**BELL BEND NUCLEAR POWER PLANT
RESPONSE TO RAI SET 1
BNP-2009-122 Docket No. 52-039**

This RAI addresses Basic Geologic and Seismic Information, as discussed in Section 2.5.1 of the Final Safety Analysis Report (FSAR), as submitted in Part 2 of the Bell Bend Nuclear Power Plant Combined License Application (COLA).

Response to NRC Request for Additional Information Set No. 1
Bell Bend Nuclear Power Plant

Figure 2.5-216 (Regional Tectonic Basins with Bouguer Anomaly)

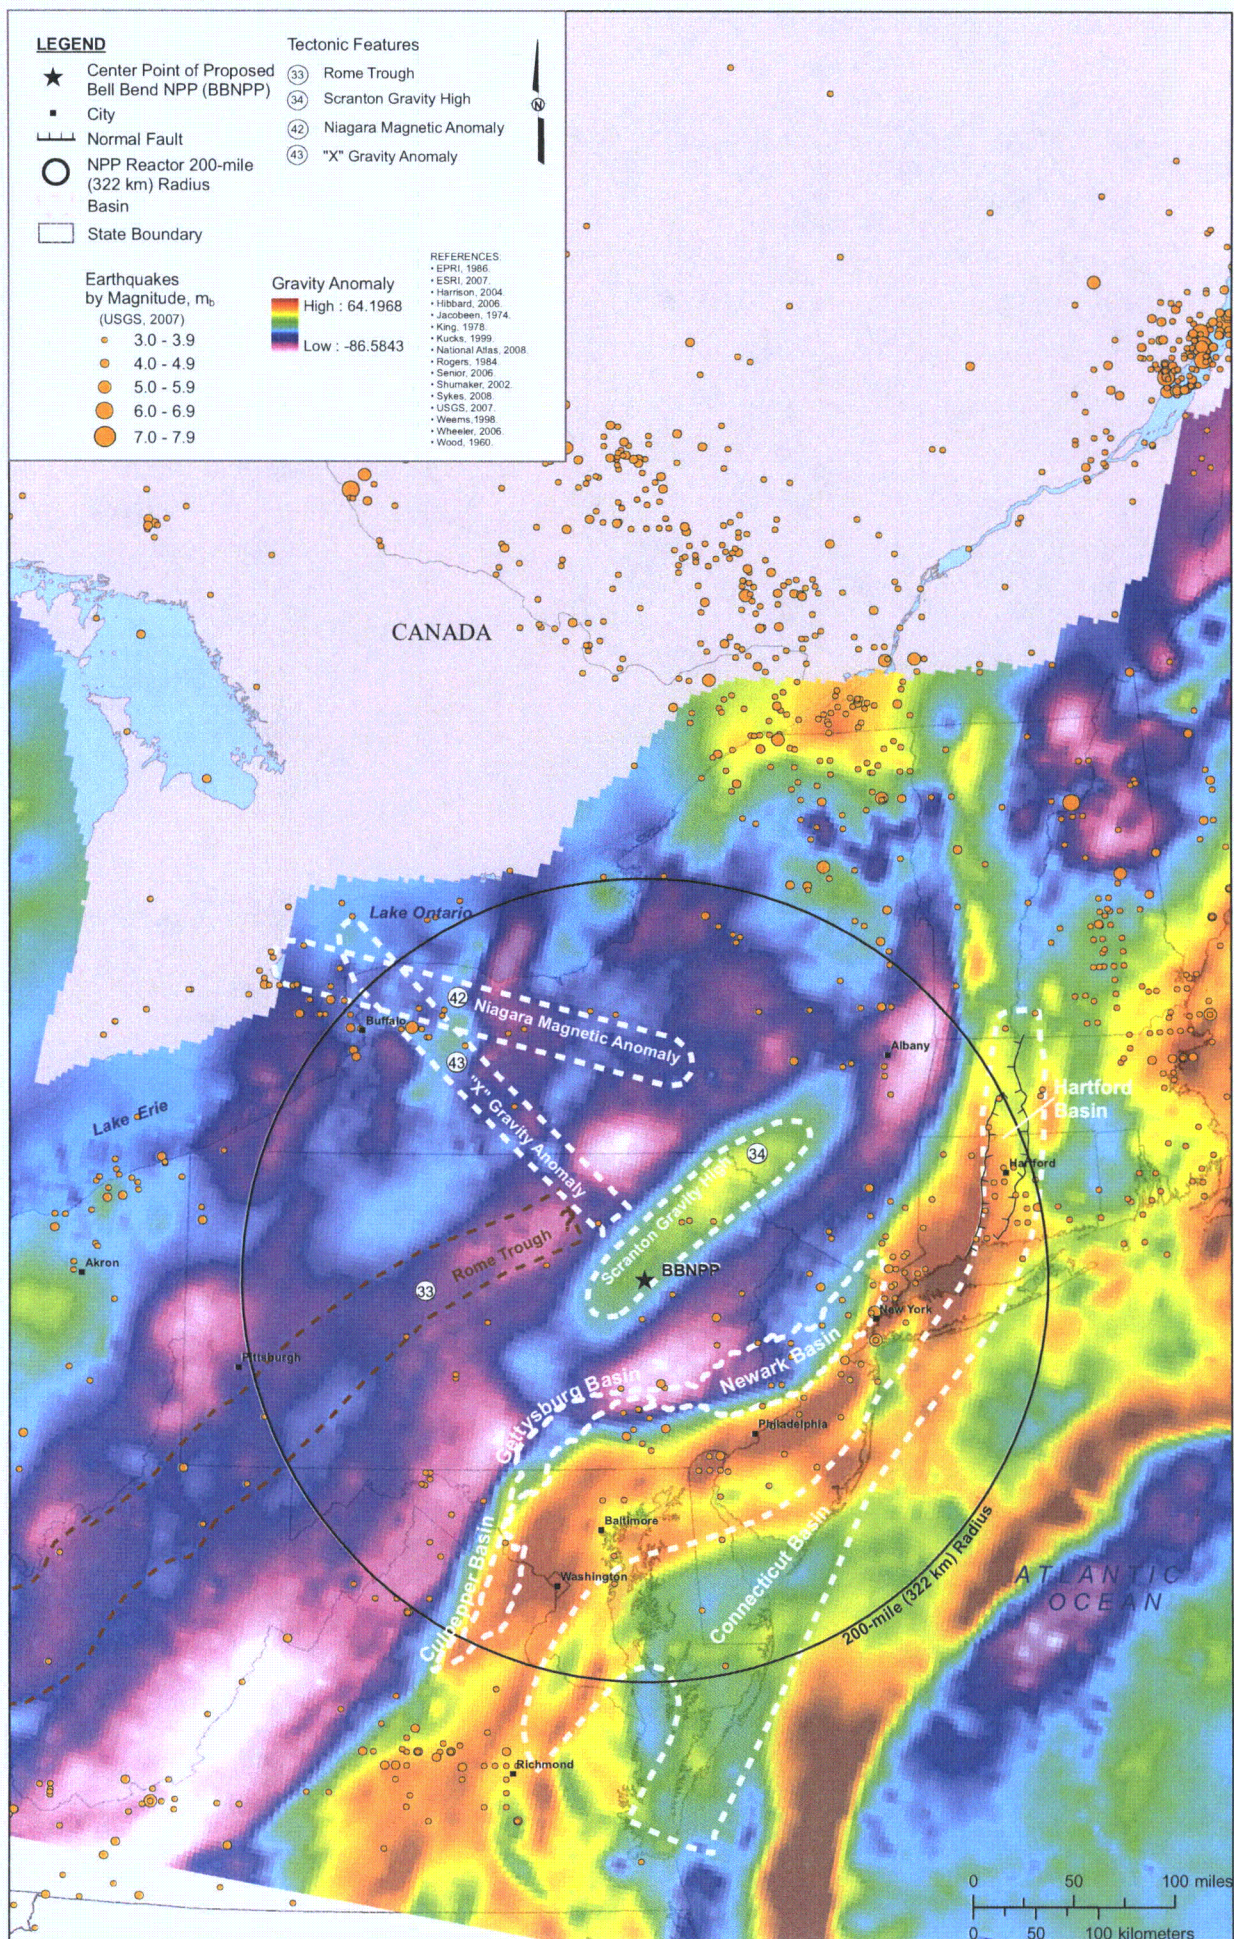
1. Separate the EPRI tectonic interpretations and illustrate them on their own maps. (EPRI tectonic interpretations are generic and not a replacement for geologic/tectonics structure maps.)
2. Provide a separate illustration of seismic source zones.
3. Provide a separate figure with all Mesozoic basins (exposed, covered, and offshore) within the regional radius and the associated faults that are known.
4. Provide a separate figure for potential field features in greater detail than shown generically in Figure 2.5-15, and include the underlying potential field data and the interpretation.
5. Indicate the age of the structures (e.g. PC, Pz, Mz, Cz) where possible.

4. Four new figures in Revision 1 illustrate the gravity and magnetic anomalies within the region and within the site vicinity (Figures 2.5-25 through 2.5-28). The description of the information provided on these figures is described in FSAR Section 2.5.1.1.4.3, Gravity and Magnetic Data and Features of the Site Region and Site Vicinity. Additionally, four new figures that show the relationships between the tectonic structures and the potential fields in the region have also been created (Figures 2.5-215 through Figure 2.5-218). These figures will be incorporated into the COLA in a future revision. Descriptions of these features on the figures are included in Sections 2.5.1.1.4.4.3, Relevant Tectonic Features with Associated Seismicity, 2.5.1.1.4.4.4, Relevant Tectonic Features with no Associated Seismicity, and 2.5.1.2.4.1 Structures of the Crystalline Basement.

Gravity data compiled at 1:5,000,000-scale for the DNAG project provide documentation of previous observations that the gravity field in the site region is characterized by a long-wavelength, east-to-west gradient in the Bouguer gravity anomaly over the continental margin (Kucks, 1999) ([Figure 2.5-25](#), [Figure 2.5-215](#) and [Figure 2.5-216](#)). Bouguer gravity values increase eastward from about -80 milligals (mgal) in the Ridge and Valley Province of western Virginia to about +10 mgal in the Coastal Plain Province ([Figure 2.5-25](#), [Figure 2.5-215](#) and [Figure 2.5-216](#)). Gravity highs, or positive anomalies, are created by accumulations of dense rock units while gravity lows are from mass deficiencies. The folded and faulted structures, basins, igneous intrusions, lithologic variations, and basement uplifts create variations in mass. Gravity anomalies occur from density contrast in size, depth, and structural depth. Long wavelengths show shallow structures or highly concentrated deep structures. Shorter wavelengths are created by shallower structures (Lavin, 1999). As shown on ([Figure 2.5-25](#), [Figure 2.5-215](#) and [Figure 2.5-216](#)), gradient gravity extends from Canada to Alabama and parallels the Appalachian Mountains. The Mesozoic rift basins show gravity lows and northeast-trending border faults ([Figure 2.5-216](#)).

Figure 2.5-206 (LiDAR Image with Topographic Sections Across the Site Vicinity)

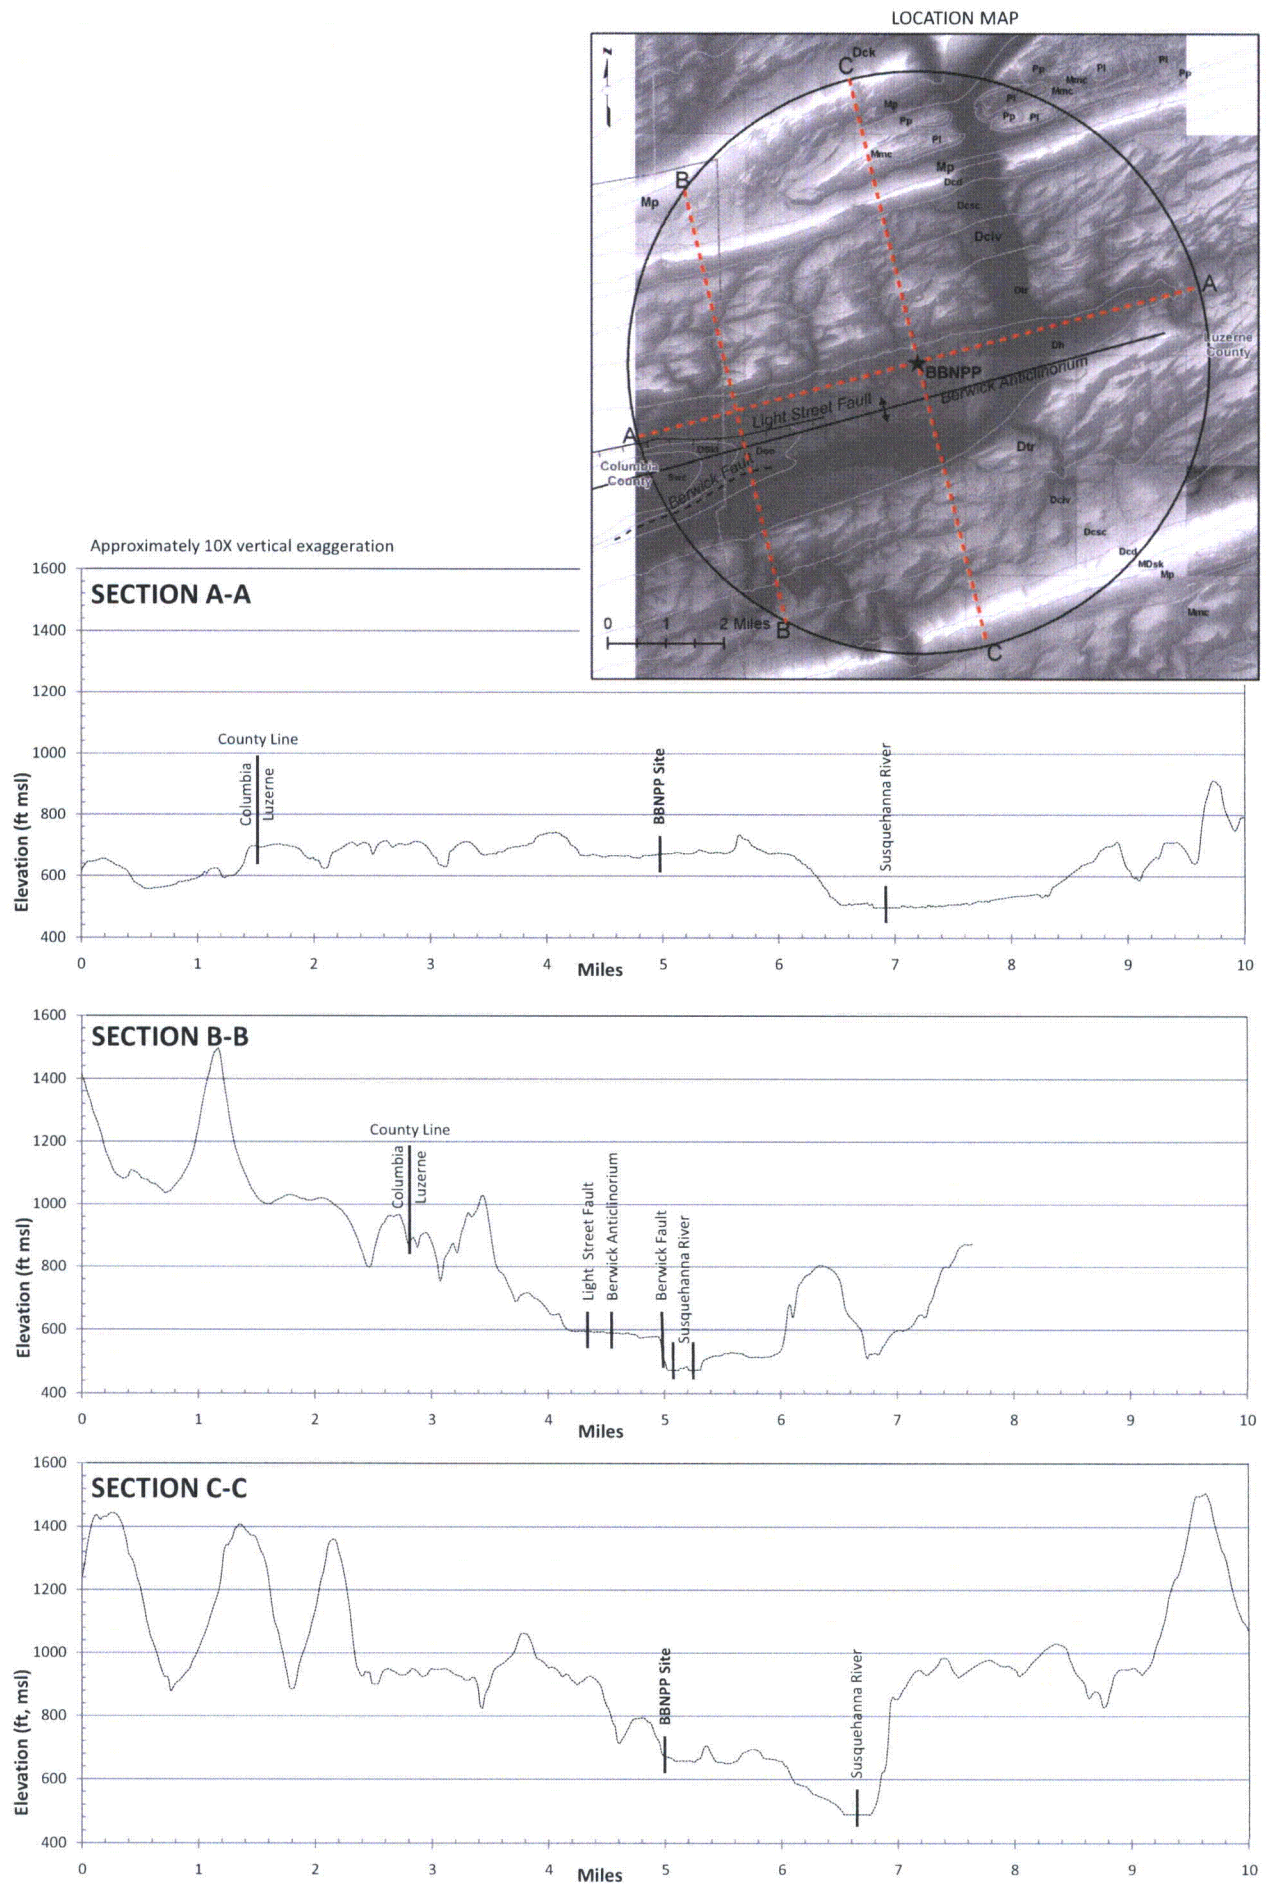
FSAR Section 2.5.3.1.2 refers the reader to Figure 2.5-105s (page 471) for illustration of the LiDAR data used to characterize the BBNPP vicinity (25 mile radius). The applicant also stated that the aerial reconnaissance investigated geomorphology and targeted numerous previously mapped geologic features and potential seismic sources (e.g., Berwick fault, Light Street fault, and Berwick Anticlinorium). The LiDAR figure that is provided is un-useable, either using paper copy or electronic image. Features in the central portion of the figure are unreadable.

Figure 2.5-105s, LiDAR Image with Topographic Sections Across the Site Vicinity, as submitted in Letter BNP-2008-006, was incorporated into Revision 1 of the COLA as Figure 2.5-206. Additional LiDAR figures have been developed to include the requested information. This information will be incorporated into a future revision of the COLA. The additional figures are provided in the pages that follow.

- Figure 2.5-206 has been revised for the following: improved LiDAR data just available for Luzerne County, smaller radius for the image, and more detail on three shorter sections.

Figure 2.5-201 {Geotechnical Site Cross Section B-B}

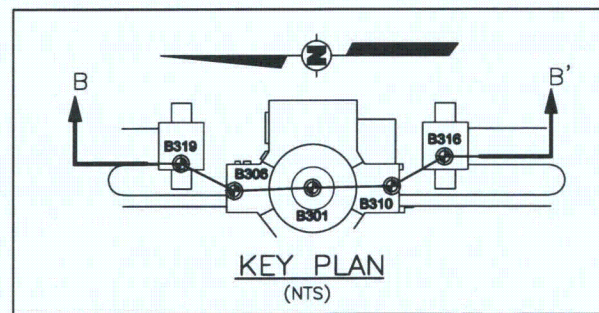
(c) The log of borehole 306 shows an unusually deep water table (figs. 2.5-97 and 2.5-100a, p. 443 and 447). Refraction profiles show that at seven places the bedrock surface deepens abruptly by several tens

Consequently, Figures 2.5-201 and 2.5-205 have been revised to reflect an interpolated water table elevation for the B-306 location, using the data from the potentiometric maps showing the local groundwater elevations in the shallow bedrock aquifer (elevations of 657-661 feet on Figures 2.4-89 through 2.4-92 in the Rev 1 FSAR). The data on those maps came from multiple wells deemed to produce reliable data, and covers the area surrounding the B-306 location.

Figure 2.5-227 (Anomalous Intervals/Areas from Seismic Refraction Survey in LiDAR Data Base Map)

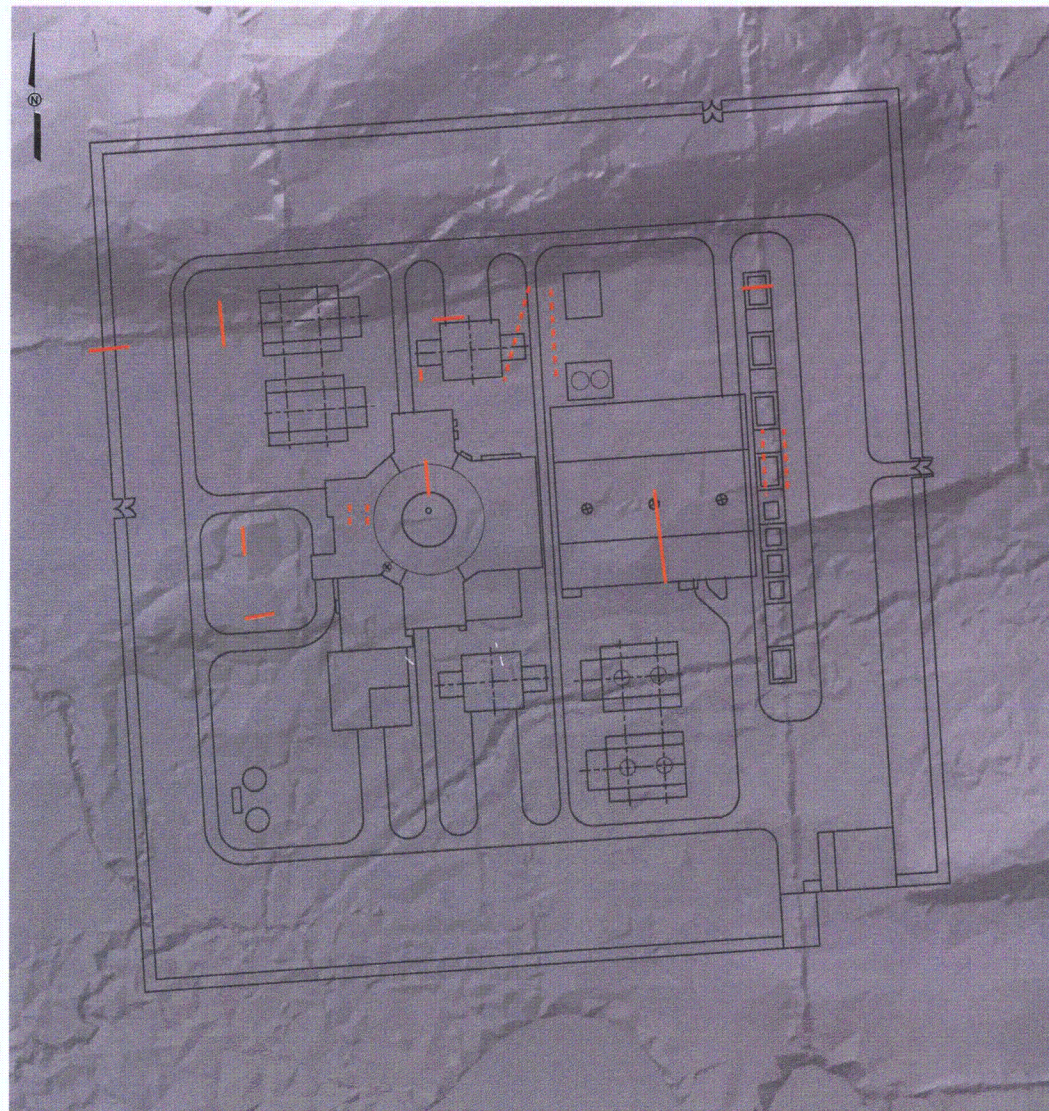
of feet (figs. 104 and 105a-f; p. 451 and 453-458). The map of the elevations of the top of bedrock shows at least two elevation anomalies that trend north to north-northeast (fig. 2.5-105, p. 452). The anomalies might represent increased permeability or increased weathering along unrecognized faults. Please show all of these anomalies on an uncolored version of figure 2.5-105, to aid NRC staff in assessing the possibility of unrecognized faults. Please design the figure so that it can be overlaid on the map requested in part a.

There is no indication in the LiDAR data base map on Figure 2.5-227 of any offset in the exposed bedrock surface adjacent to this NS trend. If the observed anomaly were a fault, motion along that fault would have been expressed in offset or changes in alignment of that rock face immediately north of the site. The following are alternative interpretations for the changes in the bedrock surface:
